# Modification Recommended Service Note

## P5004A Keysight Streamline USB Vector Network Analyzer

Serial Numbers: From MY58100696 to MY58100732

Potential lifted front panel overlay

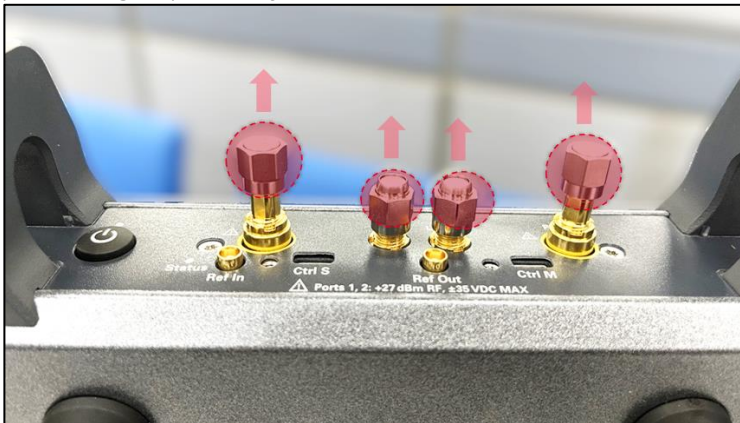
Keysight streamline series vector network analyzer (VNA) of serial number range identified in service note cover page might potentially exhibit the following lifted front panel overlay symptom.

Apart from cosmetic imperfections, the lifted front overlay could have led to non-fully attached *Ctrl S* micro-HDMI cable connector in multi-VNAs setup configuration.

-> Apply this service note only if end users' VNA is exhibiting the following symptom.

Procedure to replace the front panel overlay.

1. Remove the front handles. Detach the 50-ohm termination (LO-In, LO-Out, Port 1 & Port 2) or protecting caps if they are attached to the VNA.

2. Pry open the existing front panel overlay and remove it from front panel.
3. Clean the metal surface thoroughly and ensure it is free of adhesive residue.
4. Affix the new self-adhesive front panel overlay onto the metal surface.
5. Reinstall (reuse) the 50-ohm terminations or protecting caps accordingly.

6. Reinstall (reuse) the front handles.
